Flight Procedure Tracking Form		Action: FLIGHT CHECK	Task Type: DP	Date Open: 11/27/2009	Task #: 2009110919246427001	Request #: 20091109192464
Procedure: DP MADISONVILLE TX K51R ORIG			Airport ID: K51R	Airport: MADISONVILLE MUNI		Reimbursable #:
City: MADISONVILLE		ST: TX	GPS #:	Estimated Chart Date: 07/26/2012		FICO #:
Fac ID:	Fac. Type: <i>Pract</i>		Specialist: NEIL SIMPANEN

Procedure Review

MADISONVILLE, TX MADISONVILLE MUNI (K51R) TAKEOFF DEP/MINS, ORIG ENROUTE-NO FC: 6.12.12 PUB: 7.26.12

Airport ID:	K51R	FM 9			
Apt Name:	MADISONVILLE MUNI	No	SEGMENT	OBSTRUCTION	ELEV
City:	MADISONVILLE				
State:	TX				
			I C A	LOW-CLOSE-IN	
Proc ID:	T.O. / ODP RWY 18				
Amdt #:	ORIG

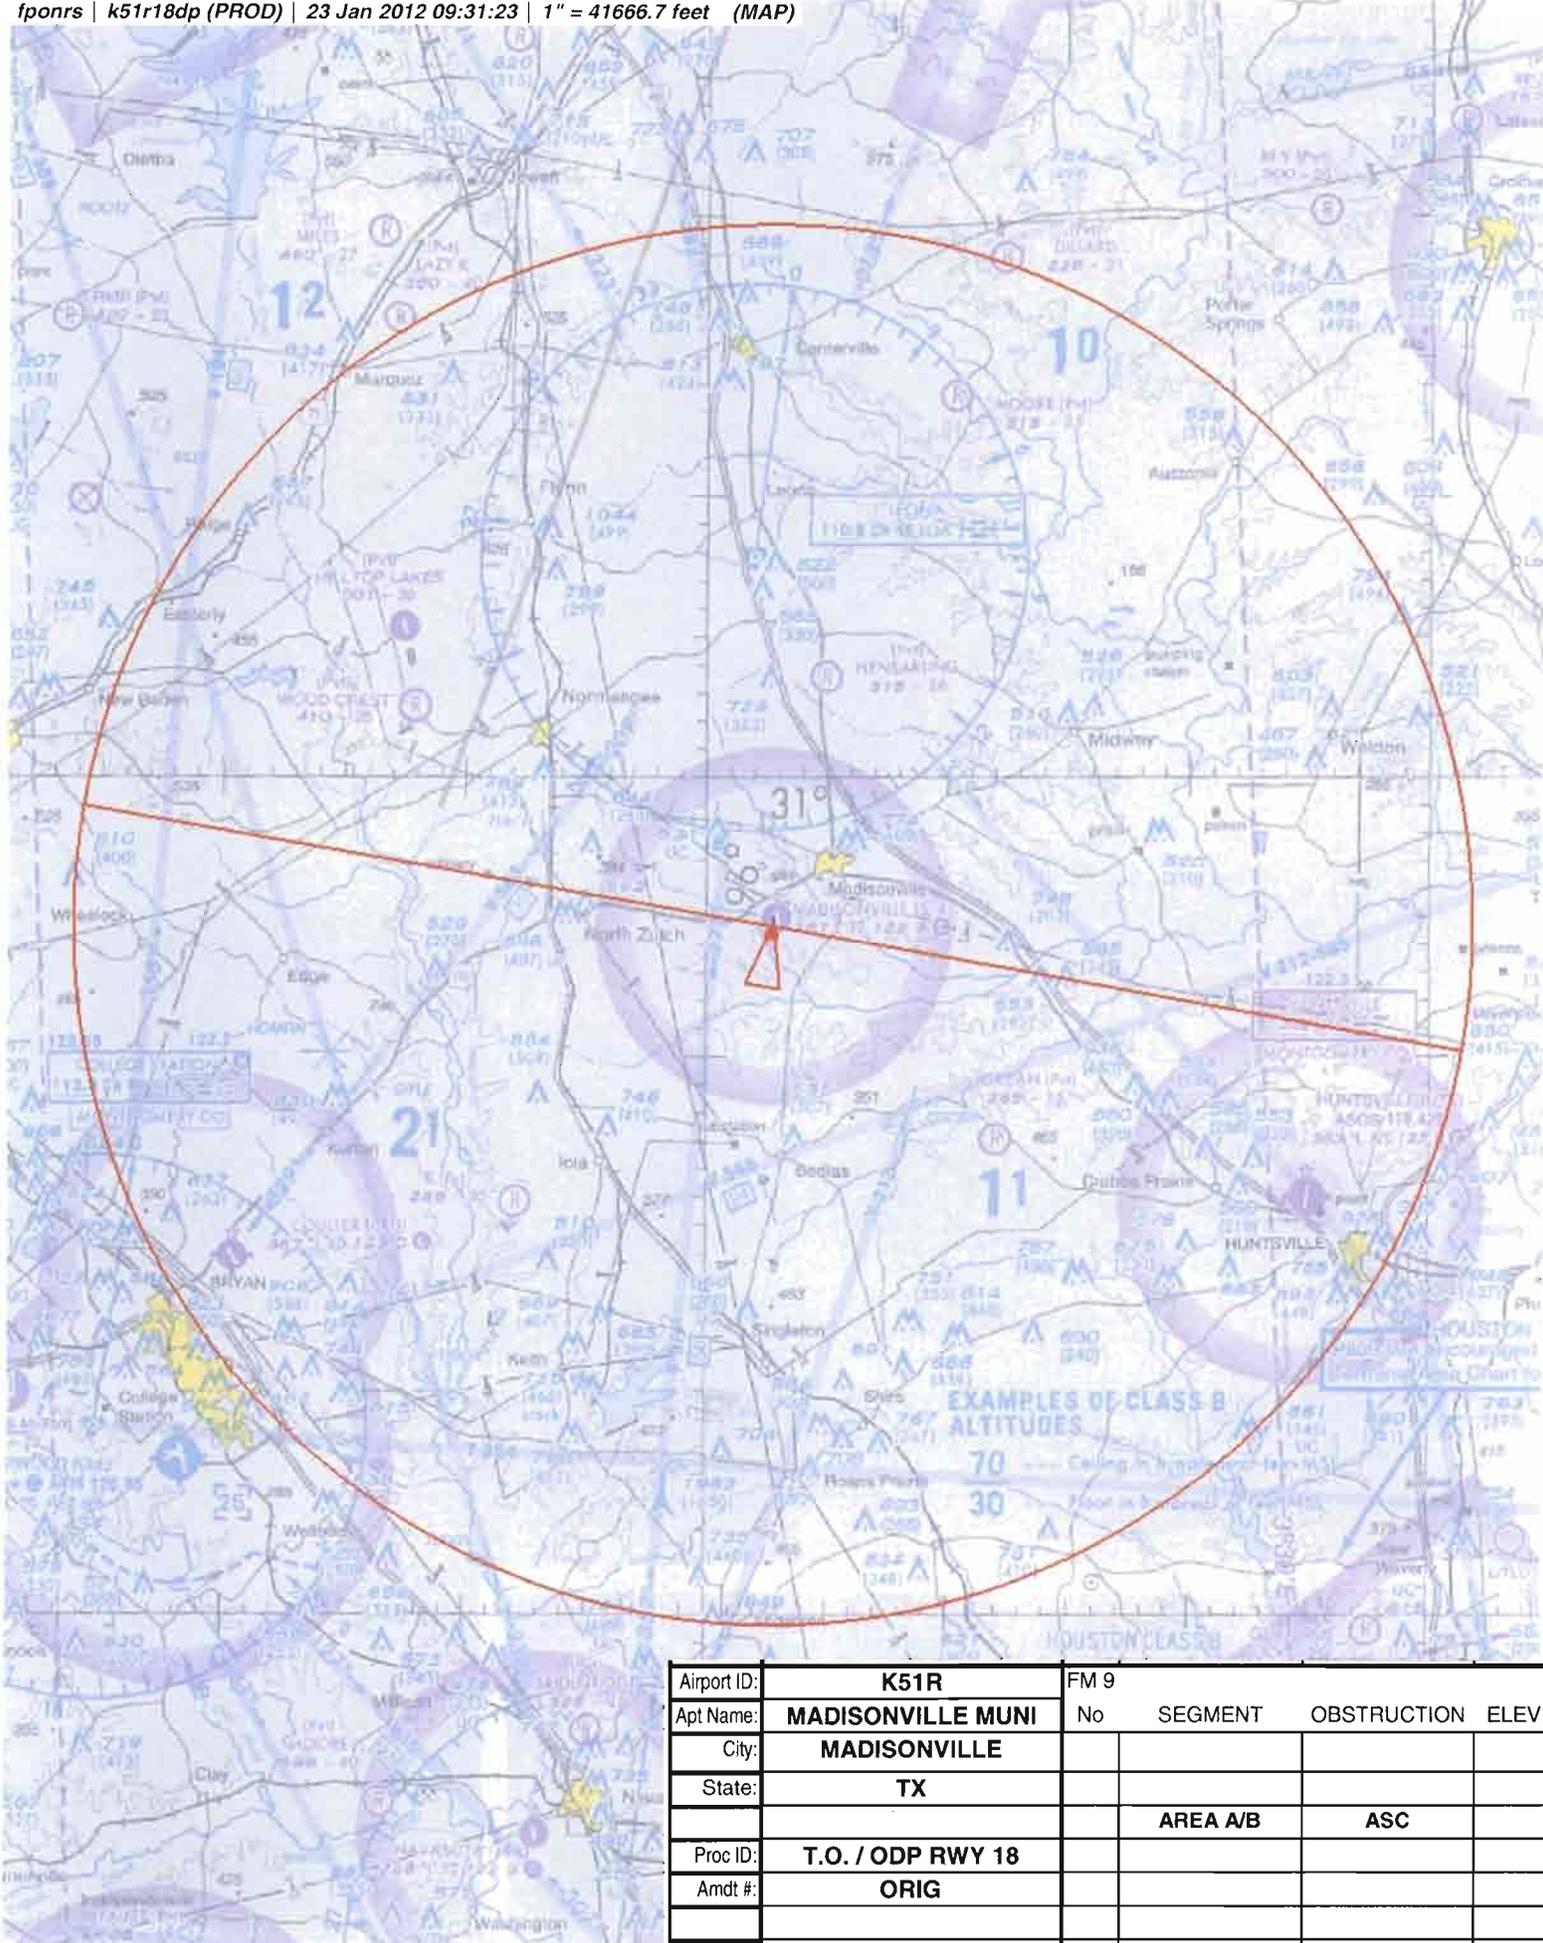
FLCK NOTE: NO CURRENT SURVEY EXISTS FOR THIS AIRPORT, NO OBSTACLES LISTED W/I 3 NM OF THE ARPT. 40 FT PWR LINES AND 50 FT TREES WERE CREATED BASED ON SEVERAL SOURCES. REQUEST FLIGHT INSPECTION VERIFY LISTED OBSTACLES CLOSE-IN TO ARPT.
